HOMESTEAD NORTH PHASE I PRELIMINARY PLAN

LETTER OF INTENT

NOVEMBER, 2020

LOI V_1 redlines.pdf Markup Summary 1-7-2021

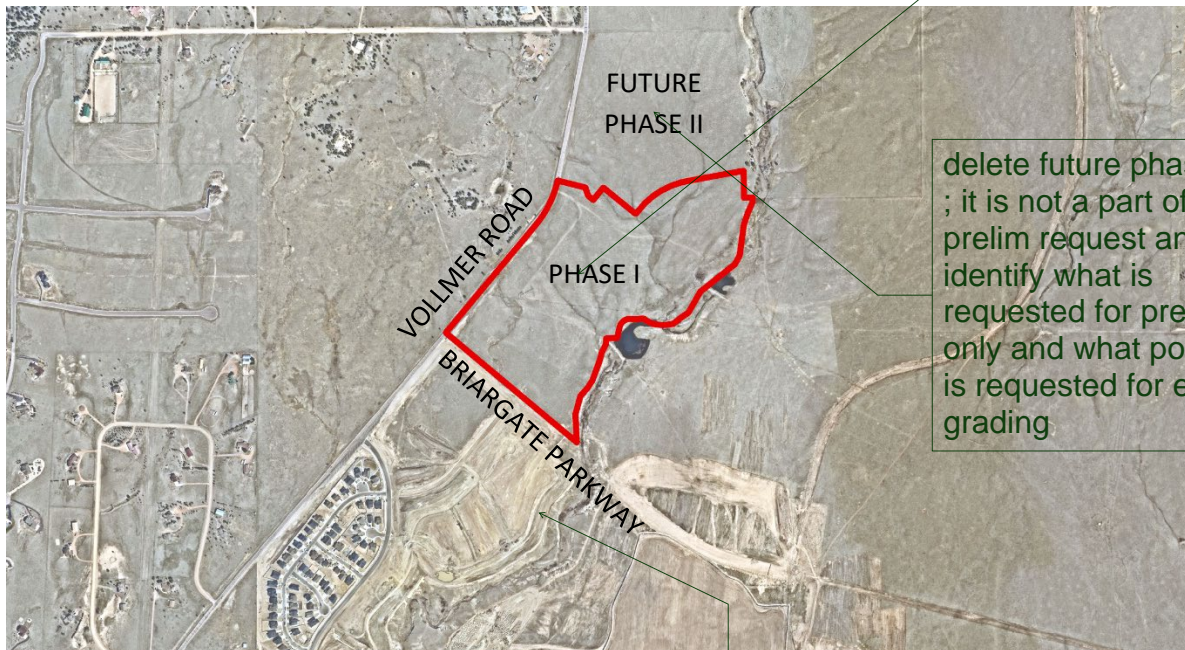
delete future phase 2 ; it is not a part of this prelim request and identify what is requested for prelim only and what portion is requested for early grading

I would use an updated map that shows development
